**MAINE DEPARTMENT OF
INLAND FISHERIES AND WILDLIFE**

ADDENDUM NO. 1

**IMPROVEMENTS AT GRAND LAKE STREAM STATE FISH HATCHERY
GRAND LAKE STREAM, MAINE**

BGS PROJECT NO.: 3289-14

LOWER PAVILION EXTERIOR ELEVATIONS

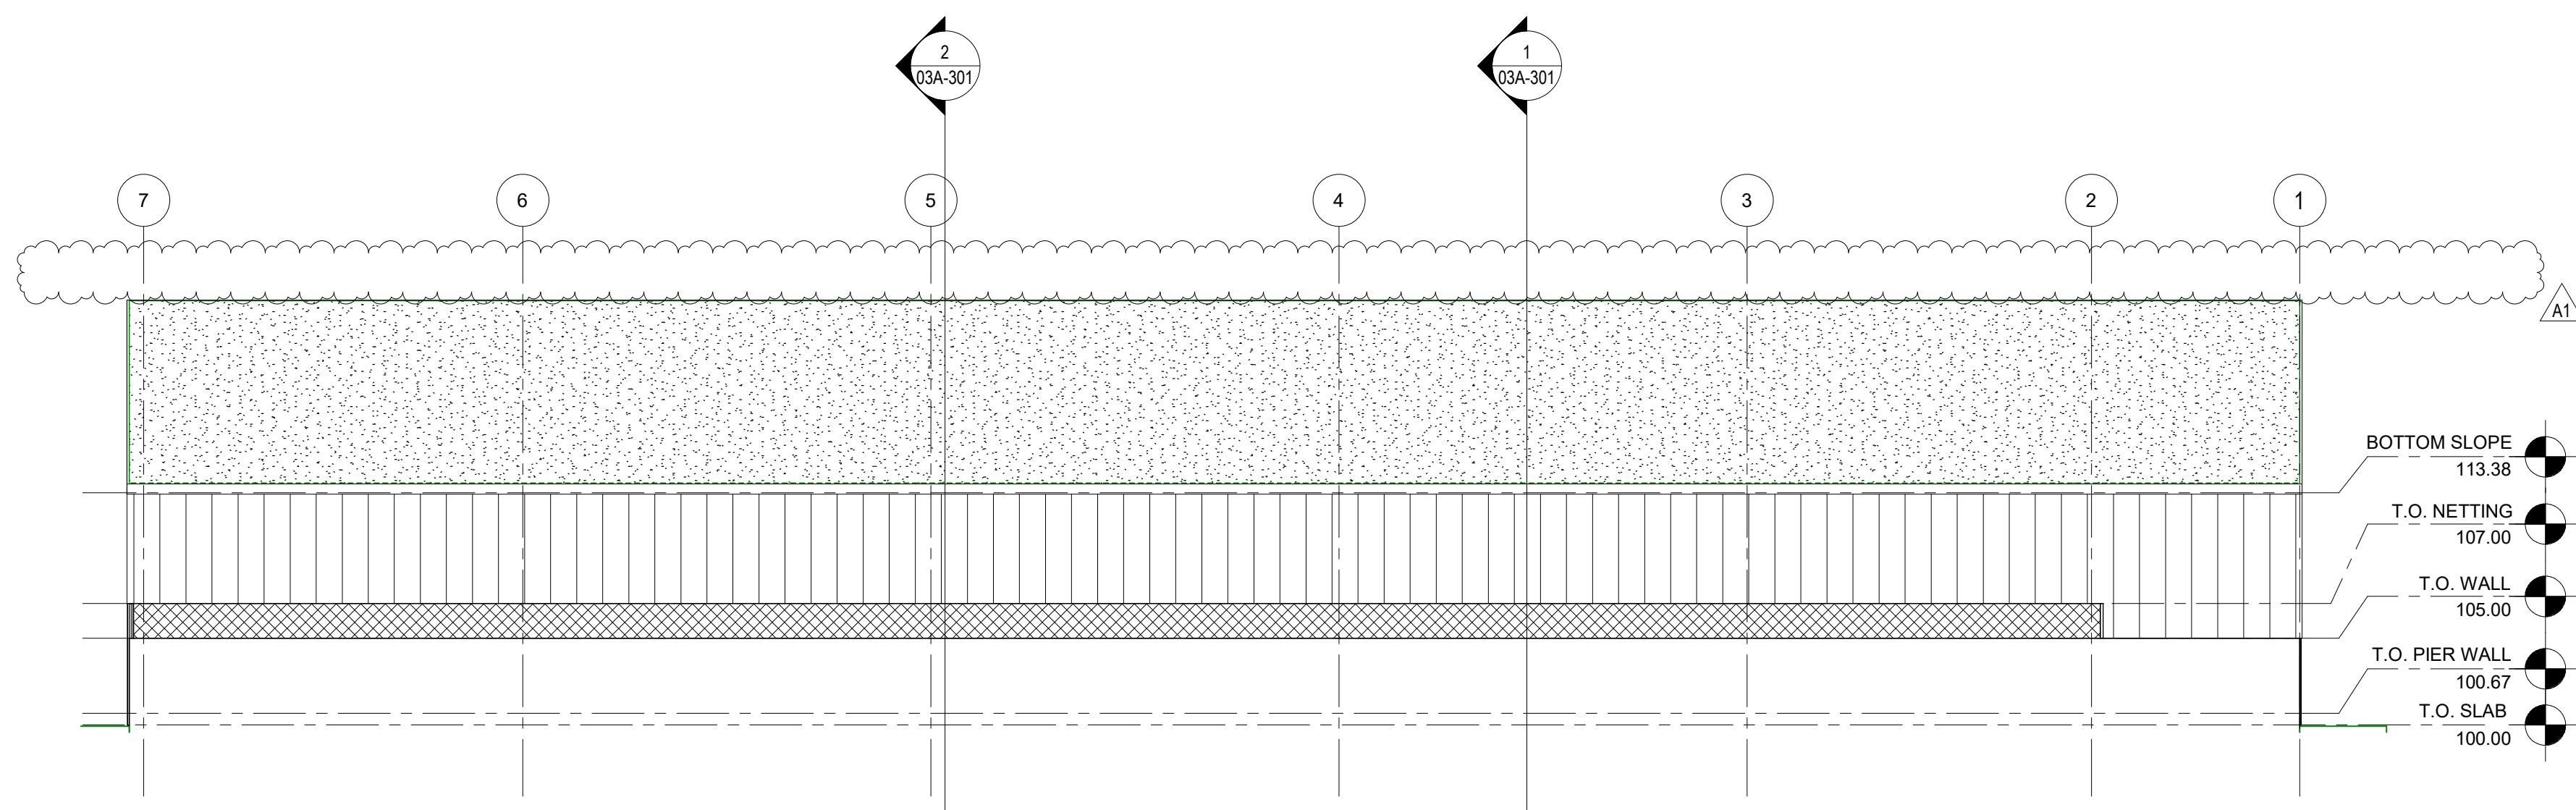
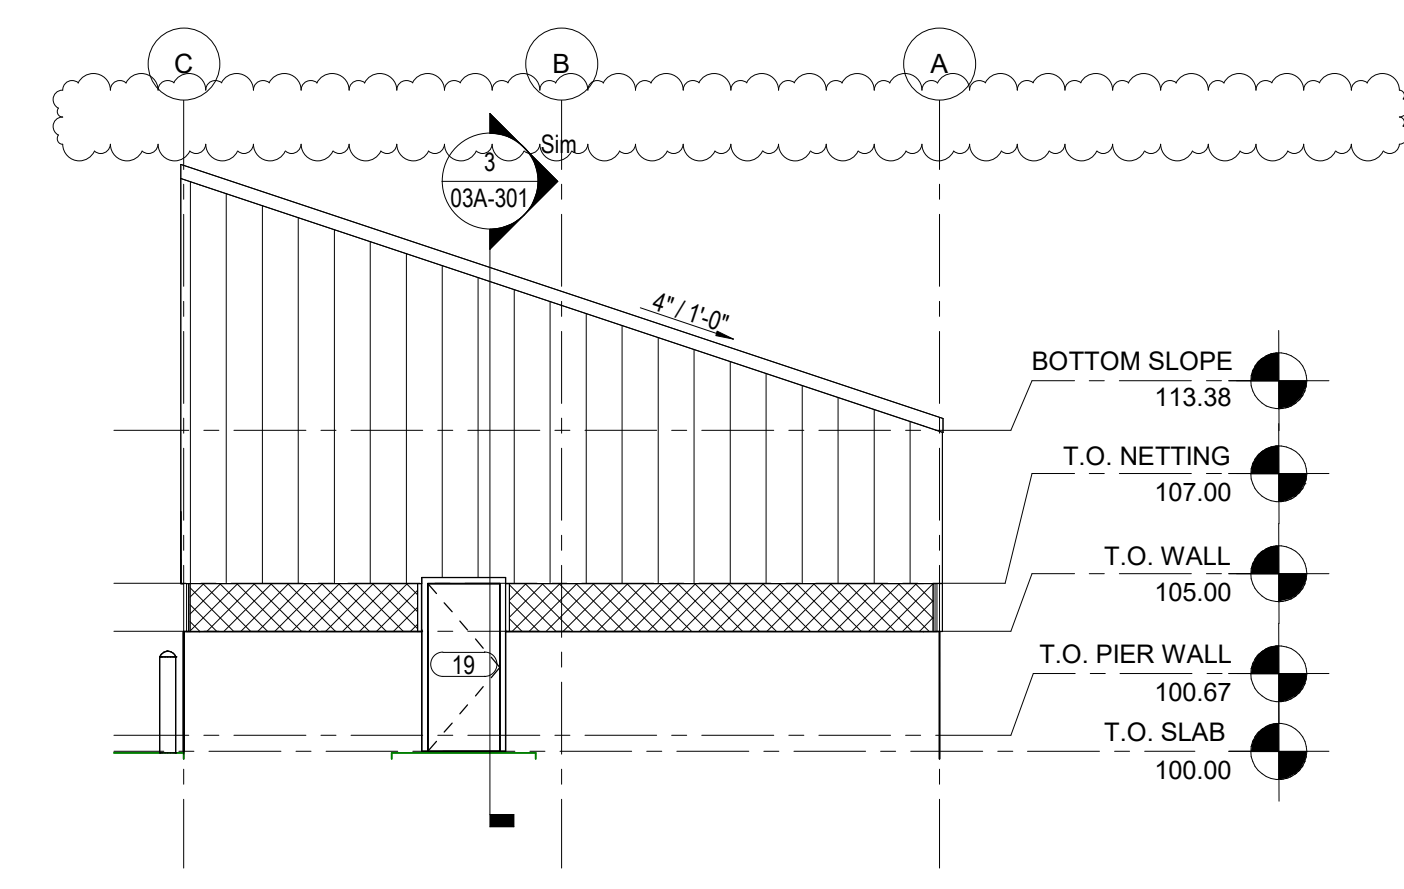
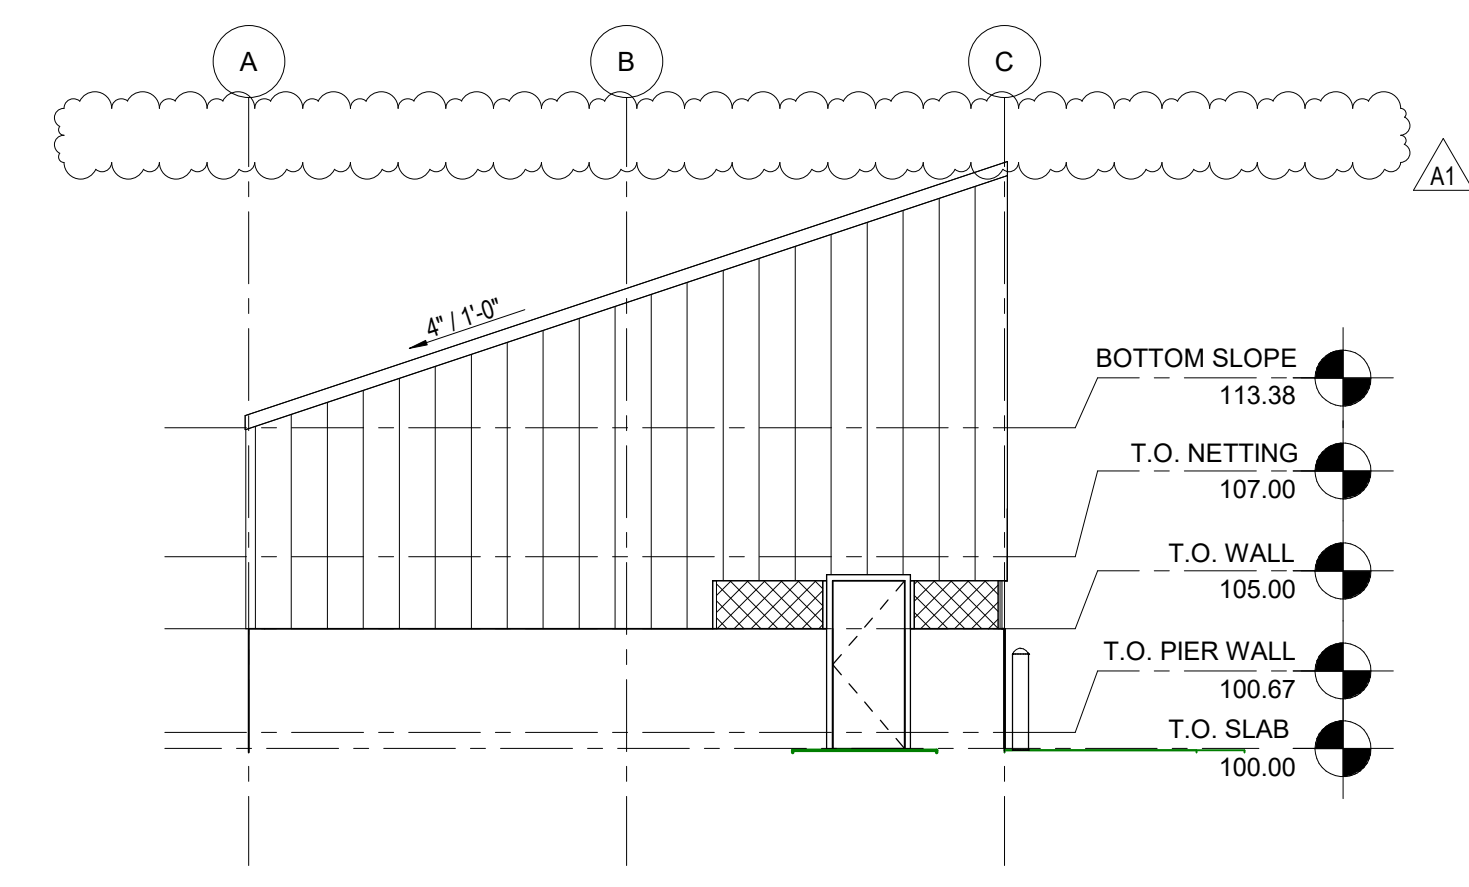
***UPDATE:** Sheet was updated to modify the feed storage garage height to 8-ft.*

LOWER PAVILION DOOR SCHEDULE AND DETAILS

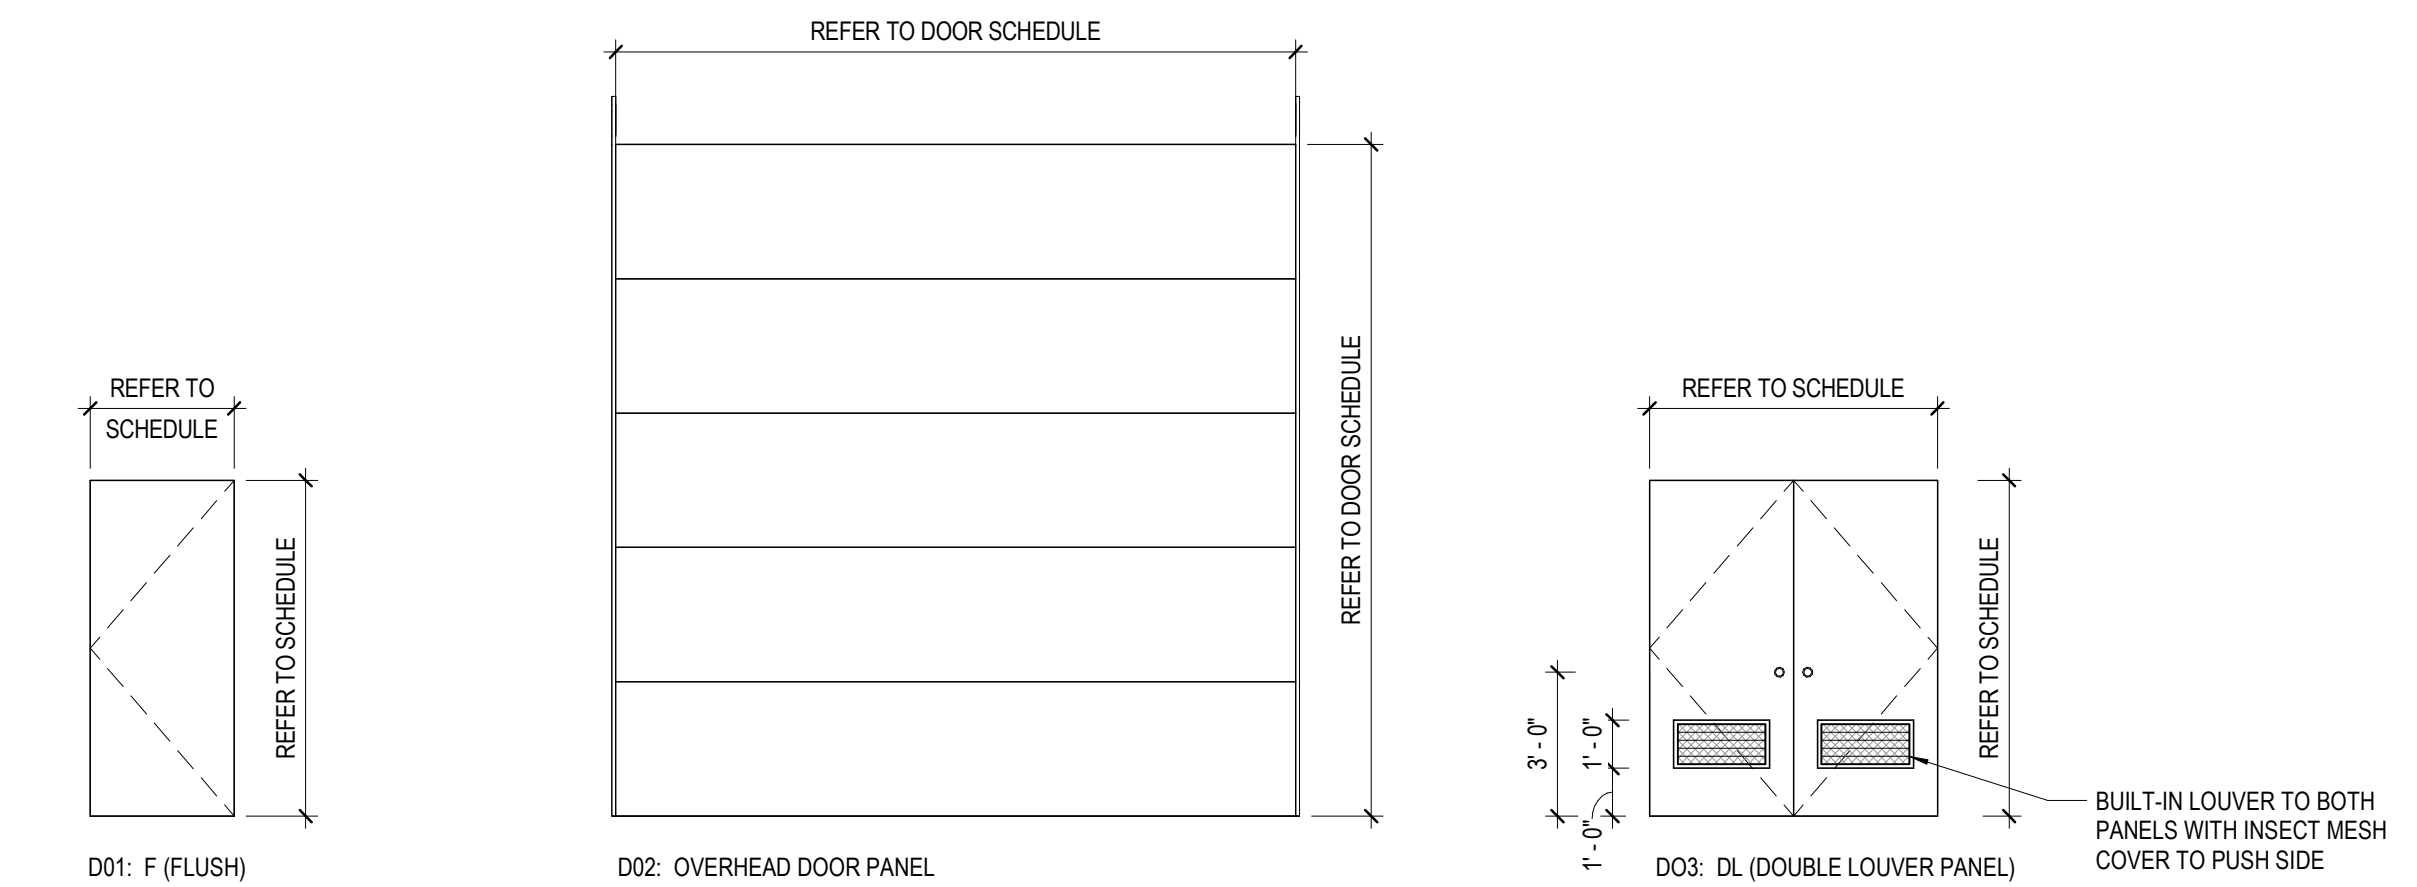
***UPDATE:** Sheet was updated to modify the door and frame schedule to update the feed storage garage height to 8-ft.*
